Response to Action Item 3-49.3

CLARIFYING QUESTIONS, DCD SECTION 3.4.1.3

Question No. 3 (AI 3-49.3): Identification of SSCs Subject to Flood Protection: DCD Tier 2, Section 3.4.1 states the following: *The reactor containment building systems to be protected from flooding are the reactor coolant system (RCS), safety injection system (SIS), reactor coolant gas vent system (RCGVS), and main steam system (MSS). The components to be protected from flooding are the valves and electric instrumentation of these systems.*

Figure 1.2-5 General Arrangement Reactor Containment Building EL. 100'-0"

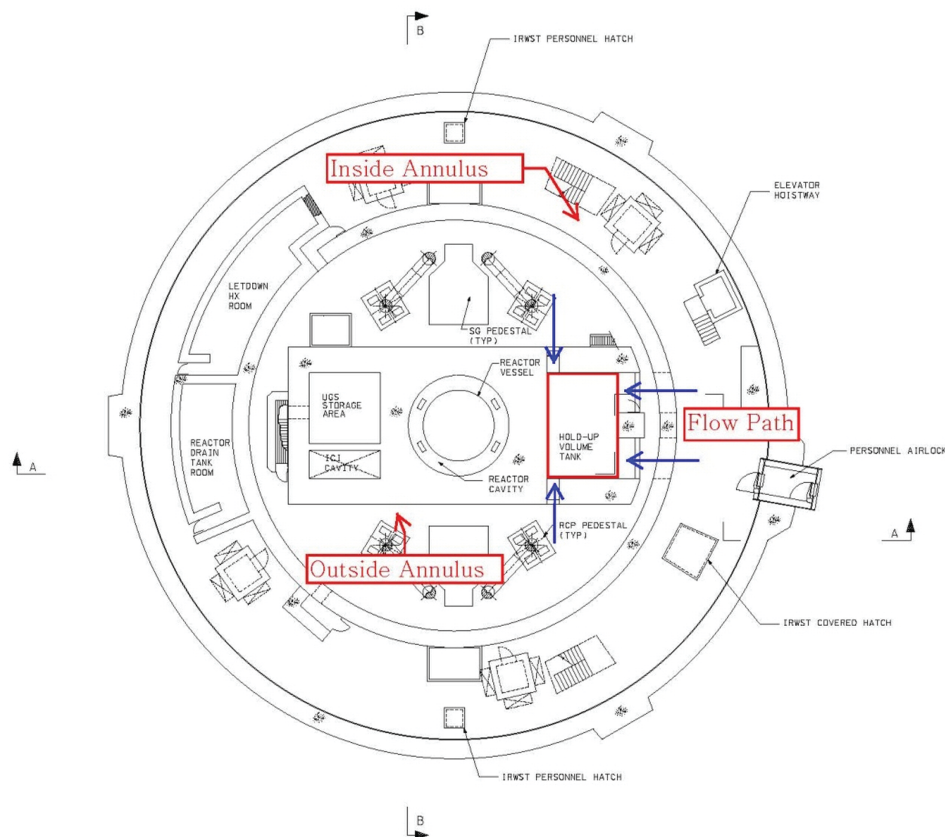
- c) Explain how the “2 ft” is determined. Is it applicable to all containment areas including annulus and areas outside annulus at EL. 100 ft.

The 2 ft is based on the volume of water from the LOCA up to 50 seconds applied to containment bottom area at EL. 100 ft 0 in which includes the annulus area. The flood level areas outside the annulus, but inside containment building are shown in the drawing below.
